SUBJECT: COMANCHE PEAK NUCLEAR POWER PLANT, UNITS 3 AND 4
DOCKET NUMBERS 52-034 AND 52-035
RESPONSE TO REQUEST FOR ADDITIONAL INFORMATION NO. 3183

Attachment 1. Response to Request for Additional Information No. 3183 (CP RAI #88)

SRP SECTION: 13.03 - Emergency Planning

Add Figures K-1 through K-16 as pages K-2 through K-17

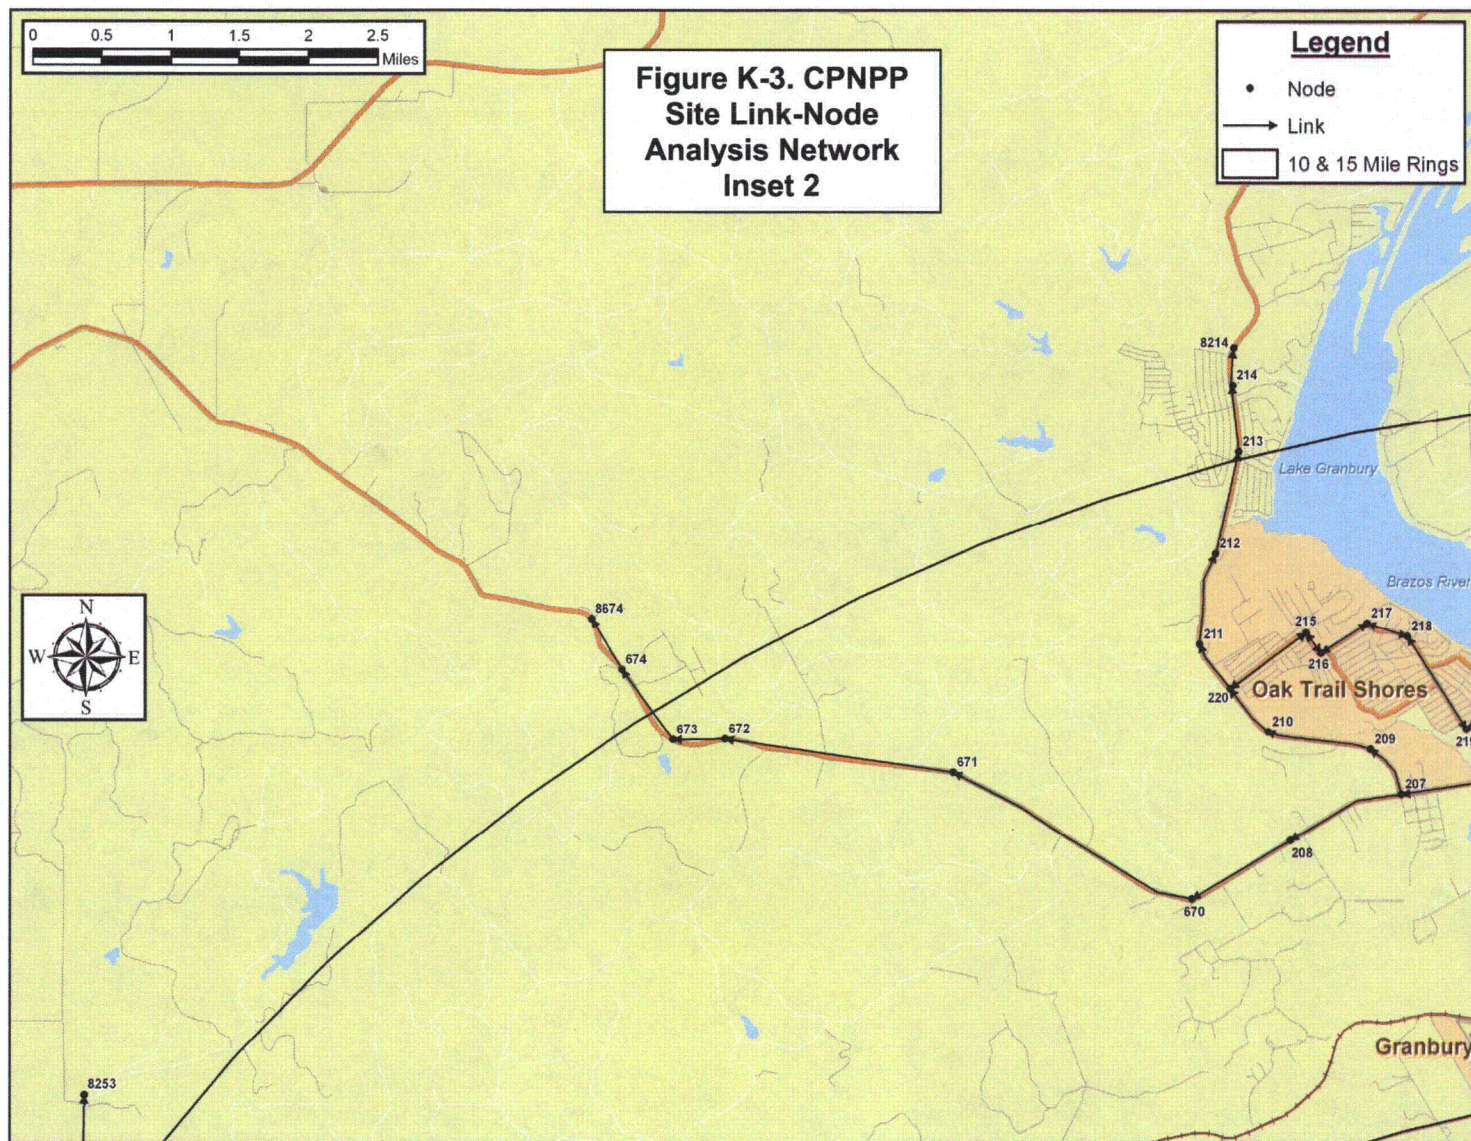
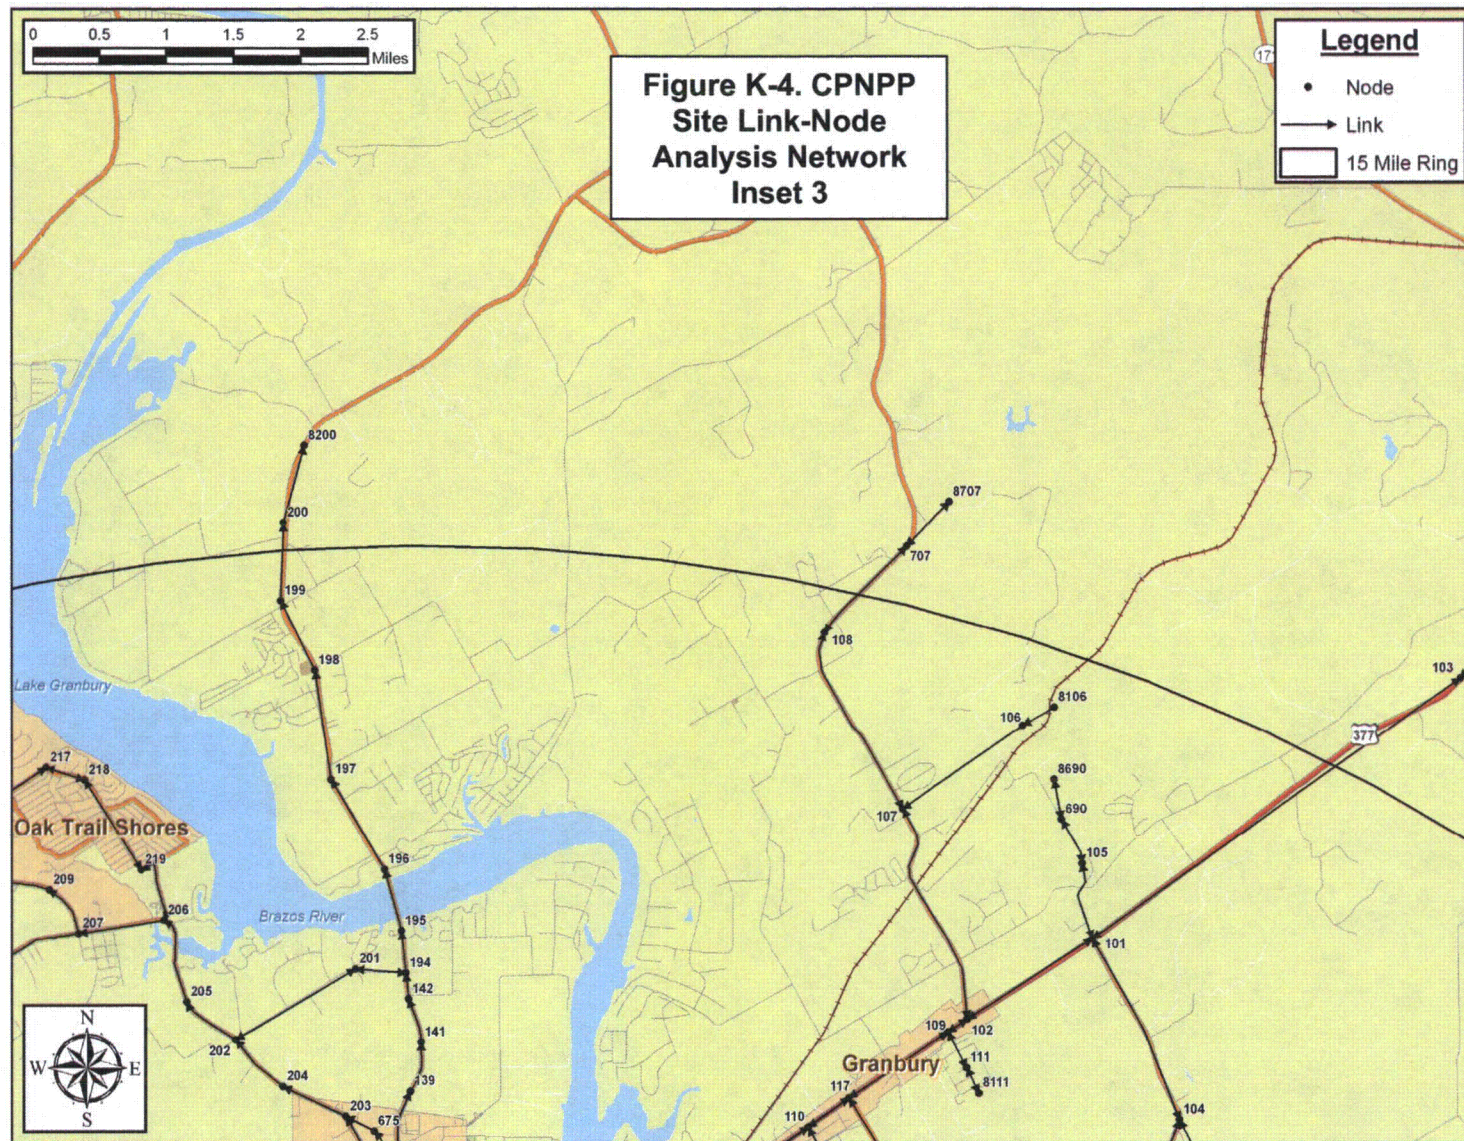
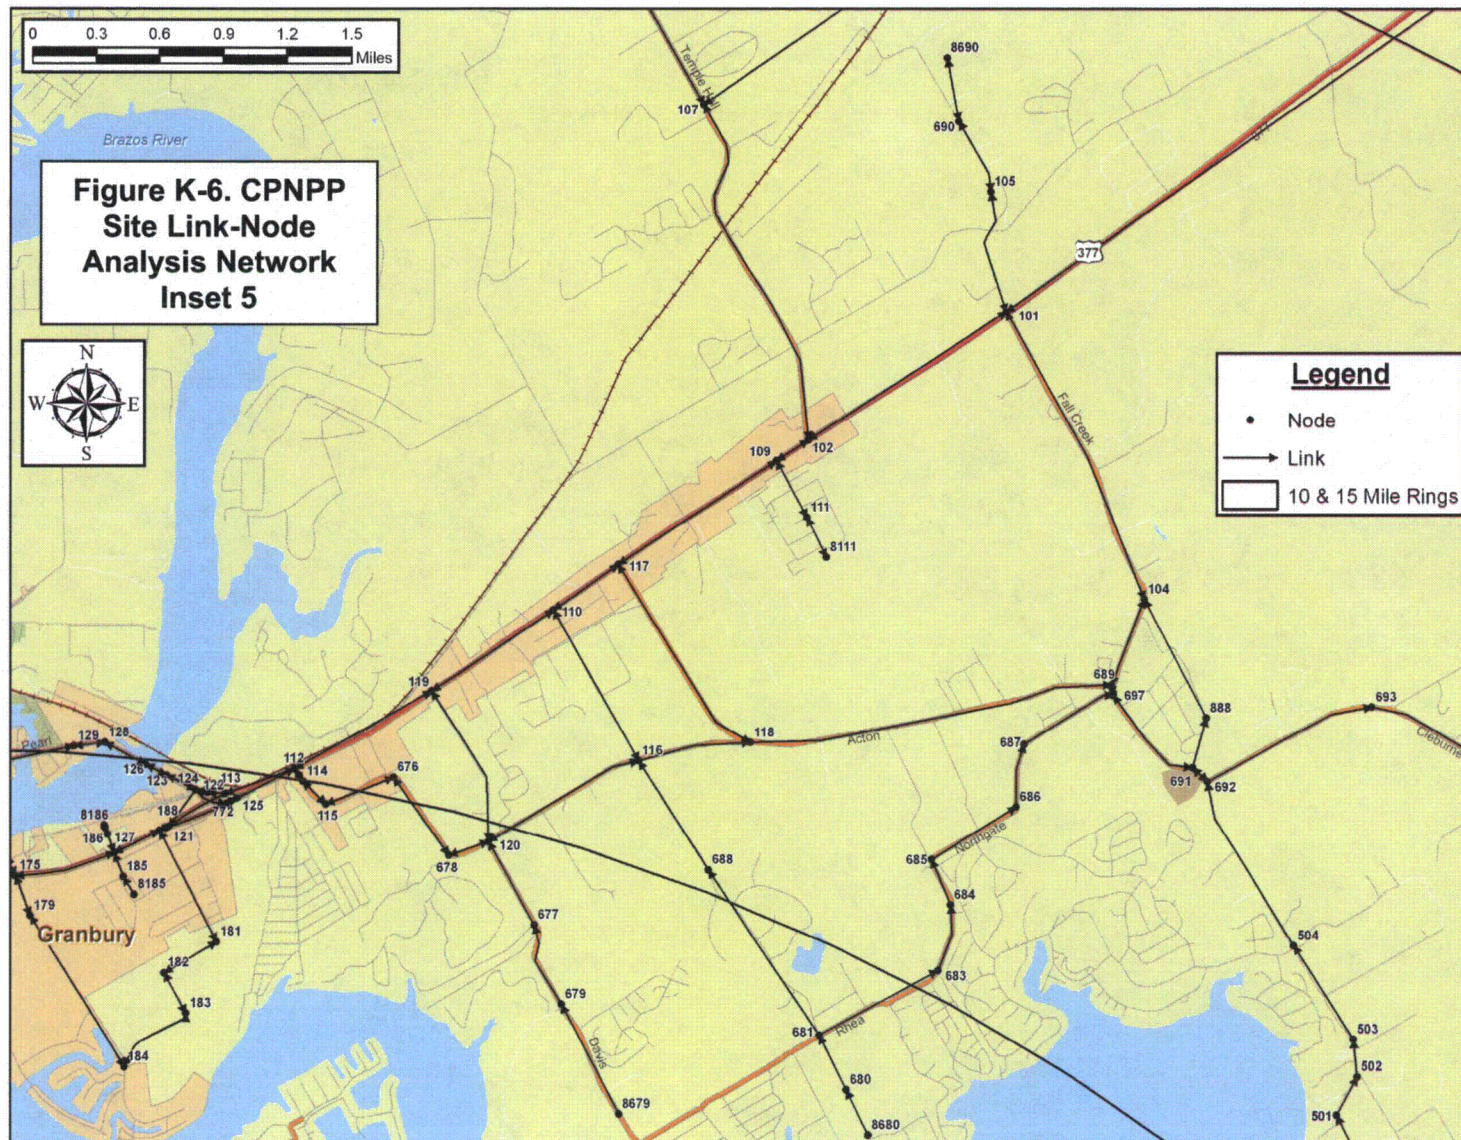
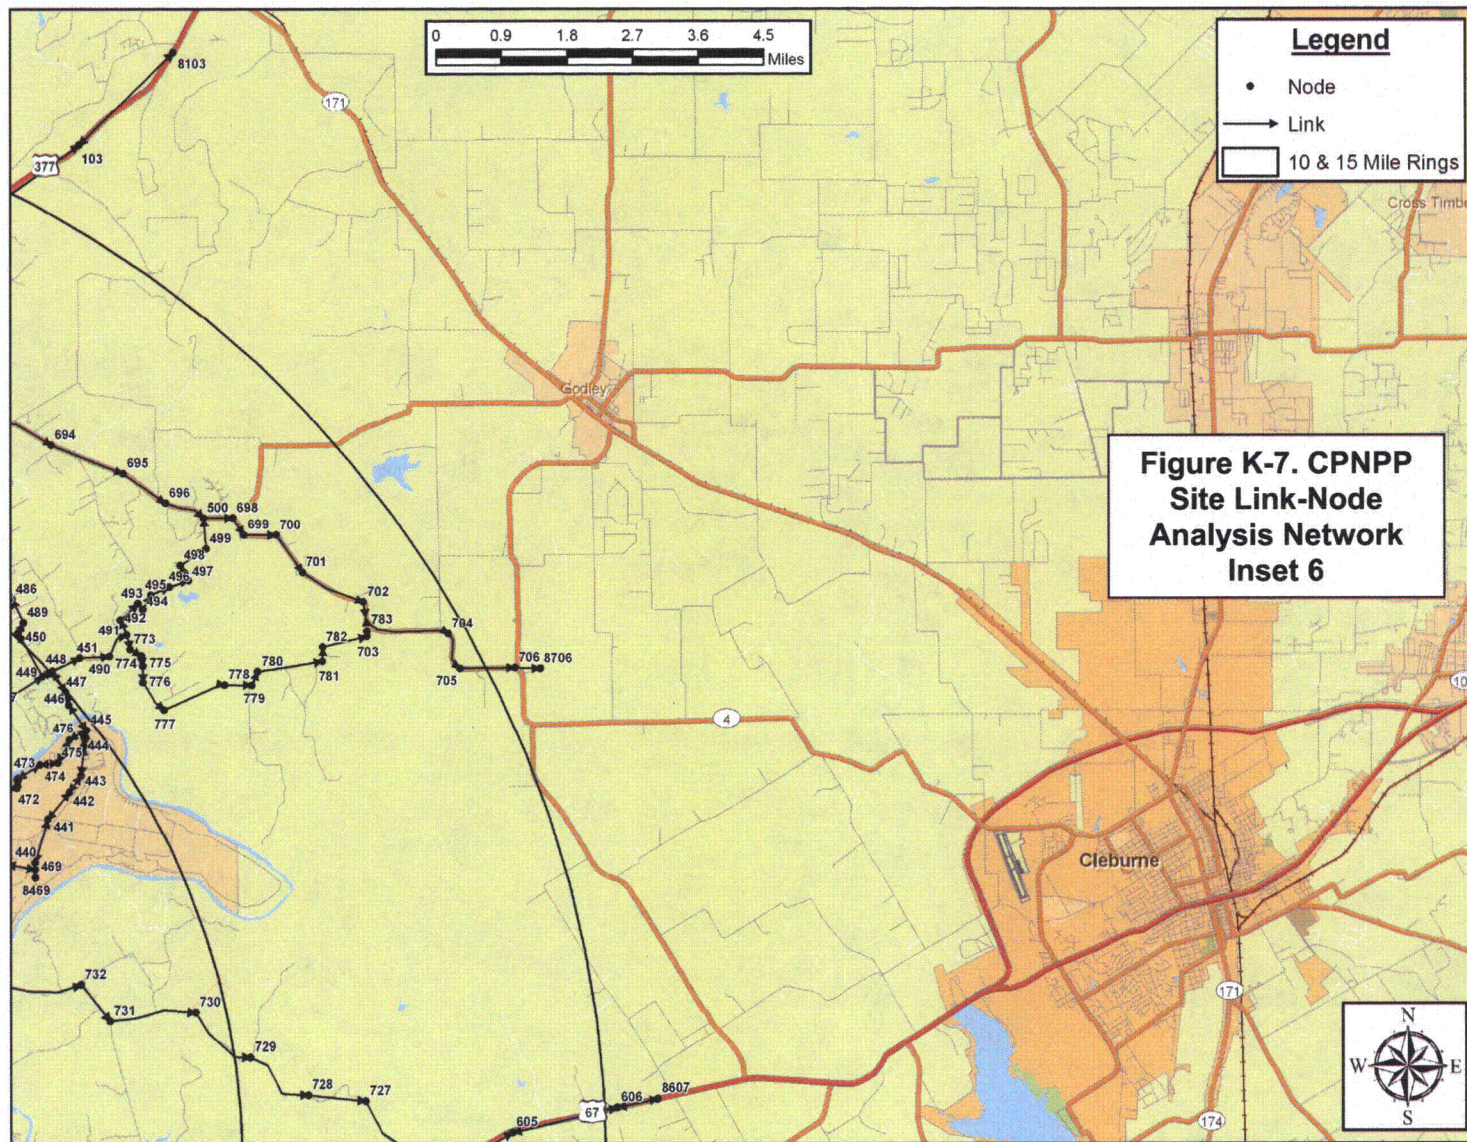
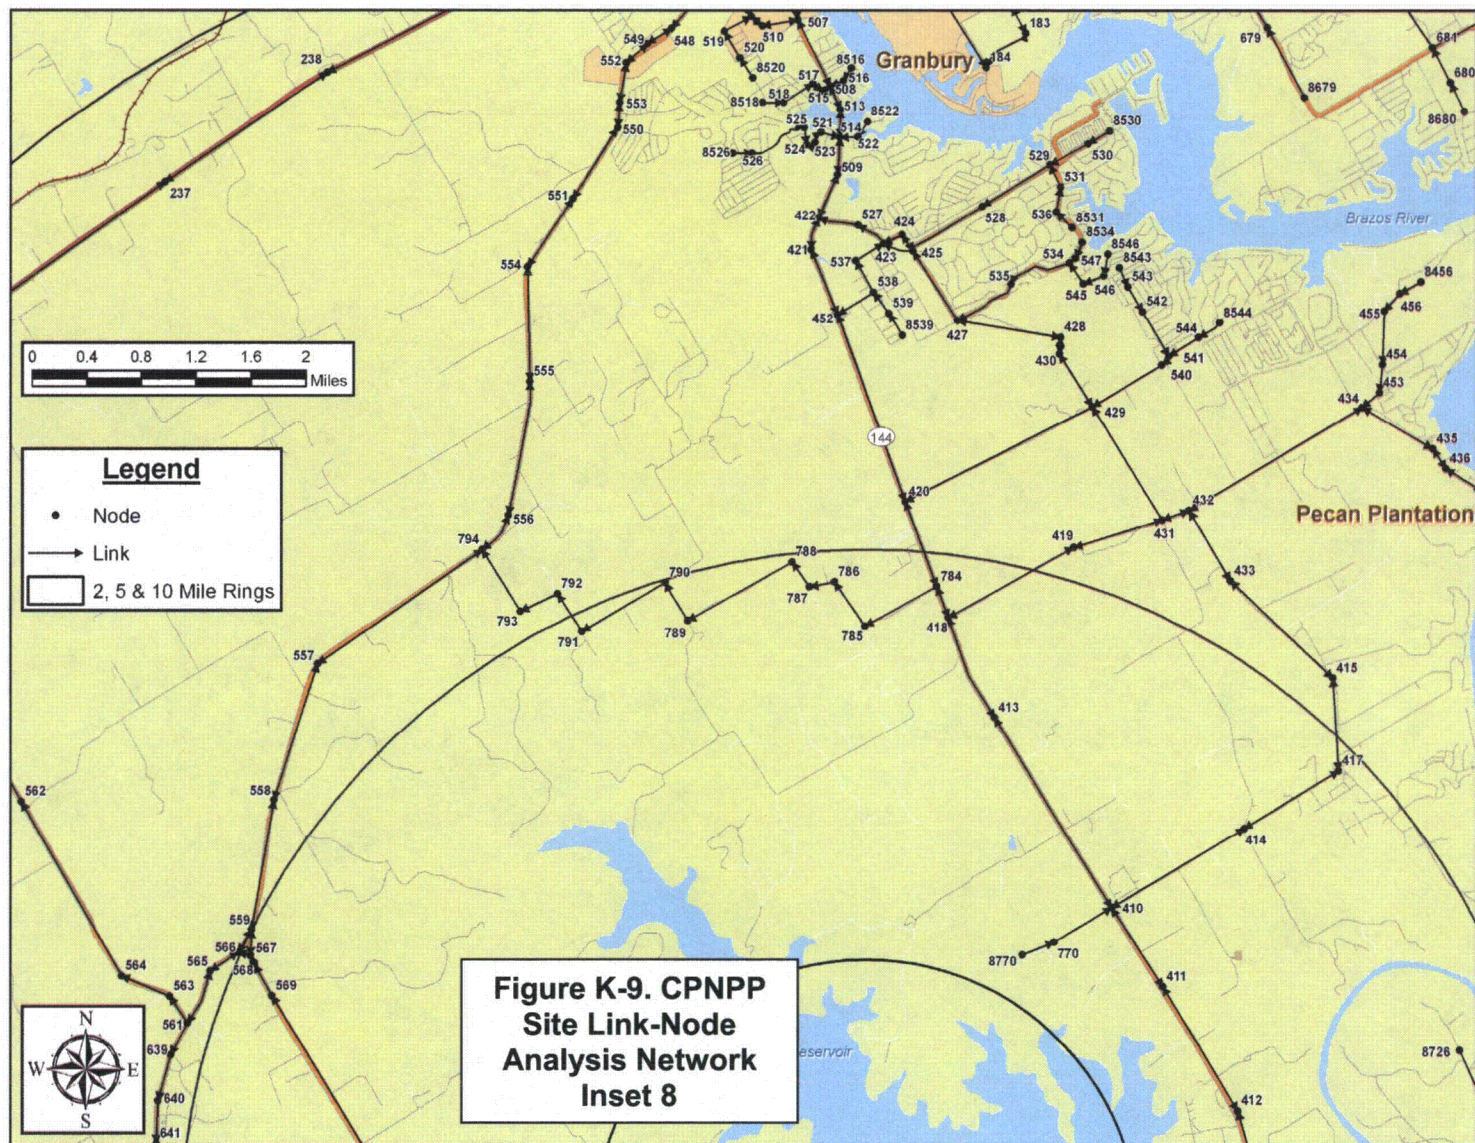
- B. Due to the scale of Figure 1-2, the node labels and link directional arrows were illegible and were not included with the original report. Figure 1-2 has been divided into several figures and will be included in Appendix K in a future revision of the ETE report. These figures show the directional arrows and annotate the nodes within the link-node analysis network. Appendix K will be renamed "Evacuation Roadway Network", the Table of Contents will be revised to reflect the new title of Appendix K and the table in Appendix K will be numbered Table K-1 and titled, "Evacuation Roadway Network Characteristics." The reference to Figure 1-2 in Section 1.3 will also be revised to reference the newly added figures in Appendix K.

Figure 1-2 presents the link-node analysis network that was constructed to model the evacuation roadway network in the EPZ and Shadow Region. The detailed figures provided in Appendix K depict the analysis network with directional arrows shown and node numbers provided. The observations made during the field survey were used to calibrate the analysis network.
